PROPOSALS

2.1 NEW S73 APPLICATION - EXTERNAL CHANGES (CONTINUED)

Figure 11 - Approved rear elevation ref. 23/1819/FUL

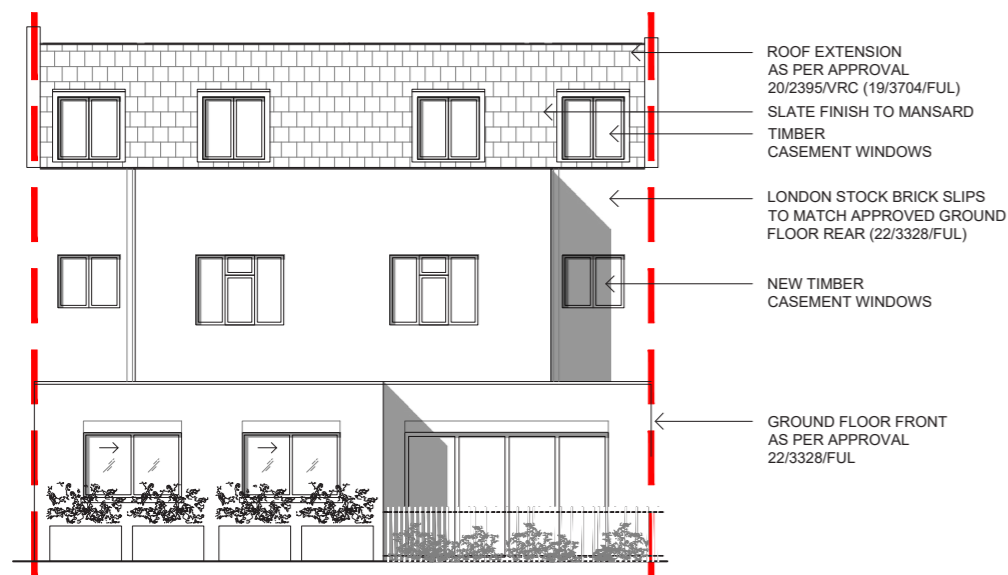
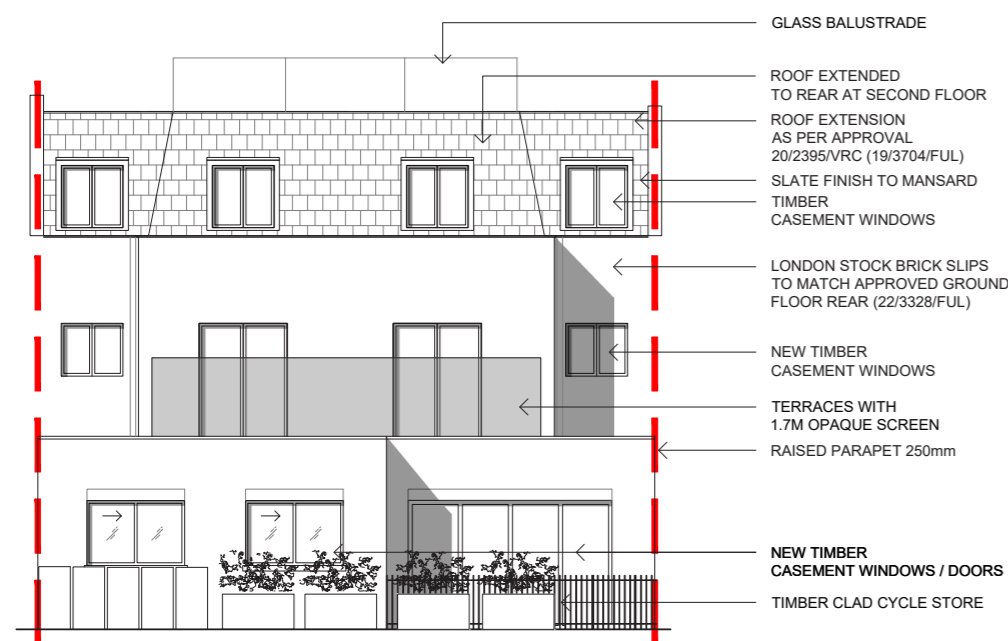
(C) Rear Facing First Floor Terraces

This S73 application seeks to add a rear facing roof terrace to the two first floor units, over the approved ground floor extension. These two terraces are identical to those proposed in the planning application ref: 21/0724/VRC, in that the balustrade is opaque and frameless. However, they are each 2 sq.m. smaller. The officer addressed these terraces in their delegated report for planning application ref: 21/0724/VRC, as follows:

For the reasons above, we surmise that these first floor rear terraces be approved as part of this S73 application.
